## MEMORANDUM

**Date:** ~~June 11, 2025~~ August 26, 2025  
**To:** Saba Hatami, BOE  
**CC:** Kaylie Coleman, Bryan Golden,  
Transportation and Public Works Department  
**Reference:** **500 S Congress PUD Traffic Impact Analysis** (C814-2024-0001) – 500 S Congress Ave,  
Austin, Final Memo

Figure 2. Improvement Extent

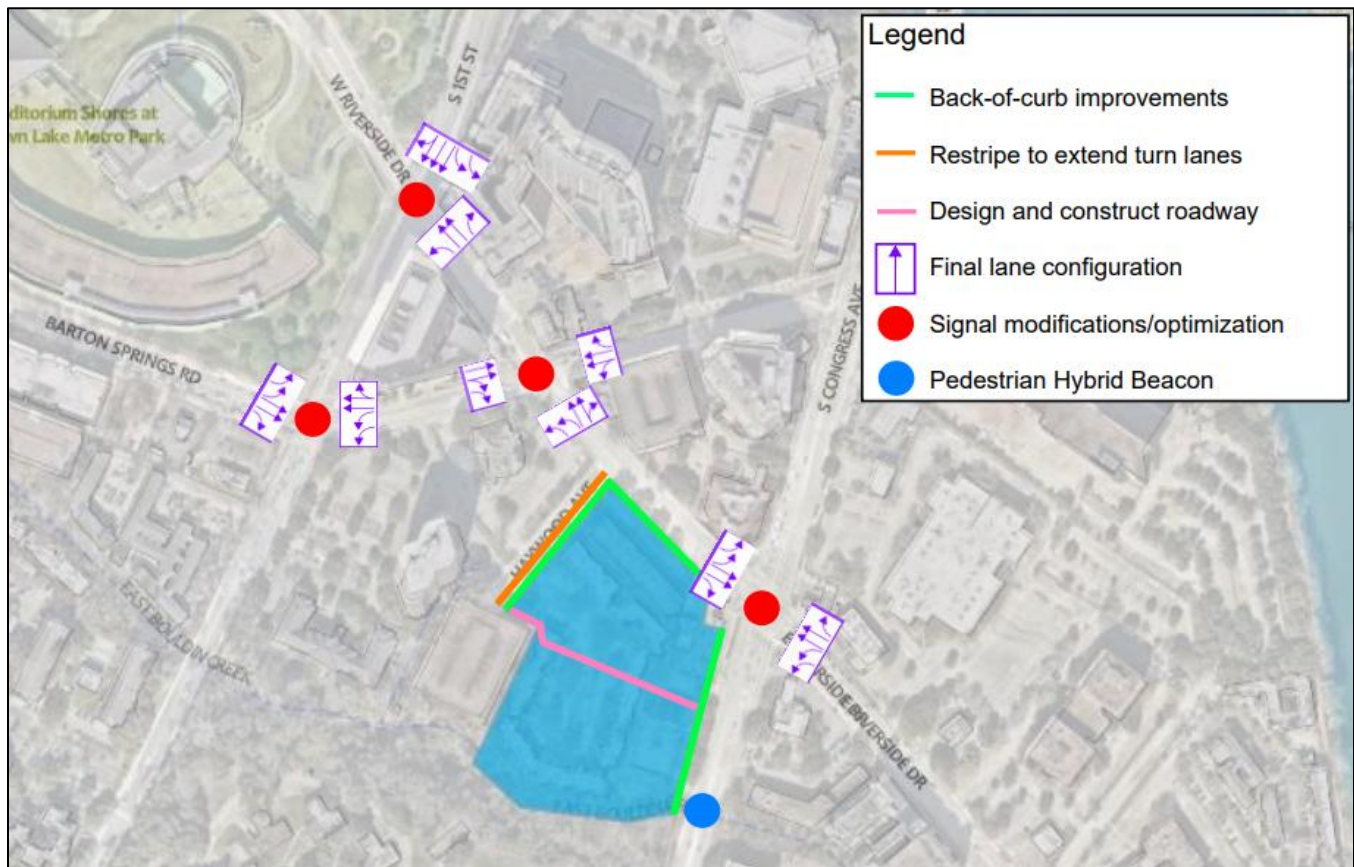
<i>Table 2. Required Improvements</i>	
<b>Name</b>	<b>Improvement</b>
Haywood Ave from W Riverside Dr to southern Haywood Ave bend (See Figures 2 and 3 for improvement extent)	Eliminate existing on-street parking on the east side of Haywood Ave to restripe the roadway to extend the NB right and left turn bays to provide additional storage
Construction of Barton Springs Rd – Congress Ave Road (See Figures 2 and 4 for the improvement extent)	Design and construct a connecting roadway including bicycle and pedestrian facilities
PHB on S Congress Ave near East Bouldin Creek (See Figure 2 for the improvement extent)	Design and construct a Pedestrian Hybrid Beacon with the coordination of TPW <b>in connection with a site plan for development of the parkland improvements (or any other timeline approved by TPW)</b>
Back-of-curb Improvements (See Figures 2, 3, and 5 for the improvement extent)	Design and construct back-of-curb improvements with the coordination of TPW <b>with corresponding site plans (or any other timeline approved by TPW) that include</b> site frontages on Haywood Ave, W Riverside Dr, and S Congress Ave

<i>Table 3. Identified Improvements</i>	
<b>Name</b>	<b>Improvement</b>
Congress Ave & Riverside Dr* (See Figure 2 for the improvement extent)	Install 1 additional LTL to create dual left turn lanes along EB Riverside Dr approach
	Install 1 additional LTL to create dual left turn lanes along WB Riverside Dr approach
	Install 1 RTL along WB Riverside Dr approach
	Modify the signal phasing to provide permissive + overlap phase for the EB right-turn movement along Riverside Dr approach
	Signal re-timing, lane assignment sign, signal head modification as needed to align with modified geometry
Riverside Dr & Barton Springs Rd* (See Figure 2 for the improvement extent)	Re-stripe NB Barton Springs Rd to convert the second through lane to a shared through-right turn lane
	Install 1 additional LTL to create dual left turn lanes along WB Riverside Dr approach
	Install 1 RTL along SB Barton Springs Rd approach

Modify the signal phasing to remove permissive + overlap phase for the right turn movement along NB Barton Springs Rd approach
	Signal re-timing, lane assignment sign, signal head modification as needed to align with modified geometry
Riverside Dr & 1 <sup>st</sup> St* (See Figure 2 for the improvement extent)	Install 1 RTL along WB Riverside Dr approach
	Install 1 additional LTL to create dual left turn lanes along SB 1 <sup>st</sup> St approach
	Modify the signal phasing to provide permissive + protected phase for the WB left-turn movement along Riverside Dr approach
	Signal re-timing, lane assignment sign, signal head modification as needed to align with modified geometry
Barton Springs Rd & 1 <sup>st</sup> St* (See Figure 2 for the improvement extent)	Install 1 RTL along EB Barton Springs Rd approach
	Install 1 additional LTL to create dual left turn lanes along WB Barton Springs Rd approach
